**SUBDIVISION,  
PLANNED UNIT DEVELOPMENT &  
PLANNING APPROVAL STAFF REPORT**

**Date: July 21, 2005**

<b><u>NAME</u></b>	Cottage Hill Baptist Church Subdivision
<b><u>LOCATION</u></b>	4255 Cottage Hill Road (Southeast corner of Cottage Hill Road and North Demetropolis Road, extending to the north side of Thigpen Drive South, and the southeast corner of North Demetropolis Road and Thigpen Drive South, extending to the north side of Troy Lane)
<b><u>CITY COUNCIL DISTRICT</u></b>	District 4
<b><u>PRESENT ZONING</u></b>	R-1, Single-Family Residential
<b><u>AREA OF PROPERTY</u></b>	14.52 acres $\pm$
<b><u>CONTEMPLATED USE</u></b>	Planning Approval to allow the expansion of an existing church; Planned Unit Development Approval to allow multiple buildings on a single building site, with shared access and parking between sites; Subdivision Approval to create two legal lots of record.
<b><u>TIME SCHEDULE FOR DEVELOPMENT</u></b>	Immediate
<b><u>ENGINEERING COMMENTS</u></b>	Must comply with all stormwater and flood control ordinances. Any work performed in the right of way will require a right of way permit.

# SITE PLAN

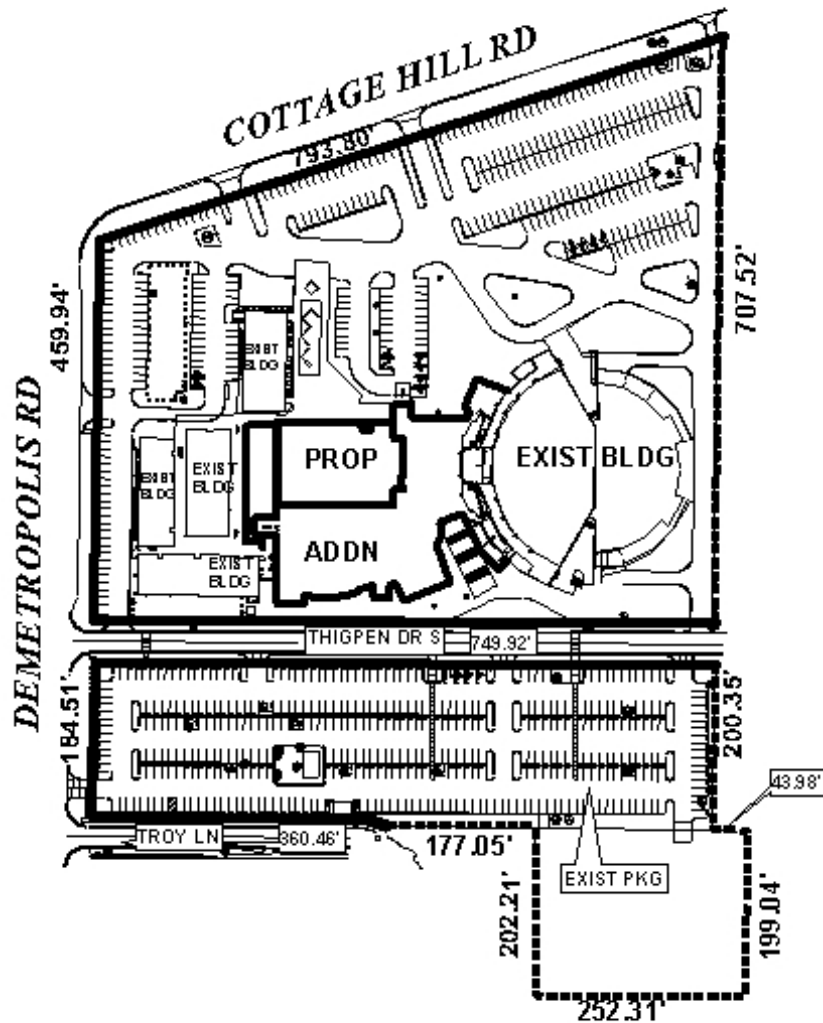
The existing parking area exceeds the number required by the Zoning Ordinance for the worship facility and associated uses. However, a portion of Lot 2 is unpaved, yet is apparently used for overflow parking; the overflow parking area should be paved with asphalt or an approved alternative surface, landscaped/buffered, and illuminated to City standards.

Sidewalks are normally required for residential and commercial developments. Lot 2 has sidewalks on its road frontages. Lot 1 appears to lack sidewalks along Cottage Hill and Demetropolis Roads, and South Thigpen Drive. Furthermore, the church’s large congregation walks from church-owned parking facilities on Lot 2, and apparently from parking located across Demetropolis (as indicated by the crosswalks on Demetropolis). As previously mentioned, the site also has school facilities, and thus children may need sidewalks to facilitate access to and from the site, and minimize safety concerns due to the proximity of a major street. Therefore, sidewalks should be required for Lot 1 along all of its road frontages.

The site plan does not indicate the location of a stormwater detention basin, which may be required for the site due to the new construction. If a detention basin is required by the City's Storm Water Drainage Ordinance, the site plan should be revised to depict the location of the basin. Revisions of the site plan, if they are significant, may require new PUD and Planning Approval applications.

Finally, there is no indication on the site plan as to the proposed location of any dumpster or other waste storage facility. If the applicant utilizes a dumpster, the location of the storage area for the dumpster must be indicated on the site plan, and the location and required screening must comply Section IV.D.9. of the Zoning Ordinance, as well as with all other applicable regulations.

**Planning Approval:** based on the preceding, it is recommended that the proposed building expansion be approved, subject to the following conditions: 1) placement of a note on the Site Plan stating that *"preservation status is to be given to the Two 48" Live Oak Trees and 54" Live Oak Tree located on the North East side of Lot 1. Any work on or under these trees are to be permitted and coordinated with Urban Forestry; removal to be permitted only in the case of disease or impending danger"*; 2) full compliance with landscaping and tree requirements of the Zoning Ordinance, to be coordinated with Urban Forestry; 3) full compliance with Section VI.A. (Off-Street Parking Requirements) of the Zoning Ordinance, as amended; 4) provision of protection buffers, in compliance with Section IV.D.1. of the Zoning Ordinance; 5) Lot 1 is limited to a maximum of three curb-cuts onto Cottage Hill Road, two curb-cuts and the existing drop-off along South Thigpen Drive, and one curb-cut onto Demetropolis Road, and that Lot 2 is limited to one curb-cut onto Troy Lane, one curb-cut onto Demetropolis Road, and three curb-cuts onto South Thigpen Drive, with the size, location and design to be approved by Traffic Engineering and conform to AASHTO standards; 6) full compliance with the Storm Water Drainage Ordinance, if required, including the provision of a storm water detention basin to be indicated on the final site plan; 7) provision of sidewalks for Lot 1 along Demetropolis and Cottage Hill Roads, and South Thigpen Drive; 8) depiction on the Site Plan of the location of any dumpster or waste storage facilities; and 9) full compliance with all other applicable municipal codes and ordinances.

**Planned Unit Development:** based on the preceding, it is recommended that the proposed building expansion be approved, subject to the following conditions: 1) placement of a note on the Site Plan stating that “*preservation status is to be given to the Two 48” Live Oak Trees and 54” Live Oak Tree located on the North East side of Lot 1. Any work on or under these trees are to be permitted and coordinated with Urban Forestry; removal to be permitted only in the case of disease or impending danger*”; 2) full compliance with landscaping and tree requirements of the Zoning Ordinance, to be coordinated with Urban Forestry; 3) full compliance with Section VI.A. (Off-Street Parking Requirements) of the Zoning Ordinance, as amended; 4) provision of protection buffers, in compliance with Section IV.D.1. of the Zoning Ordinance; 5) Lot 1 is limited to a maximum of three curb-cuts onto Cottage Hill Road, two curb-cuts and the existing drop-off along South Thigpen Drive, and one curb-cut onto Demetropolis Road, and that Lot 2 is limited to one curb-cut onto Troy Lane, one curb-cut onto Demetropolis Road, and three curb-cuts onto South Thigpen Drive, with the size, location and design to be approved by Traffic Engineering and conform to AASHTO standards; 6) full compliance with the Storm Water Drainage Ordinance, if required, including the provision of a storm water detention basin to be indicated on the final site plan; 7) provision of sidewalks for Lot 1 along Demetropolis and Cottage Hill Roads, and South Thigpen Drive; 8) depiction on the Site Plan of the location of any dumpster or waste storage facilities; and 9) full compliance with all other applicable municipal codes and ordinances.
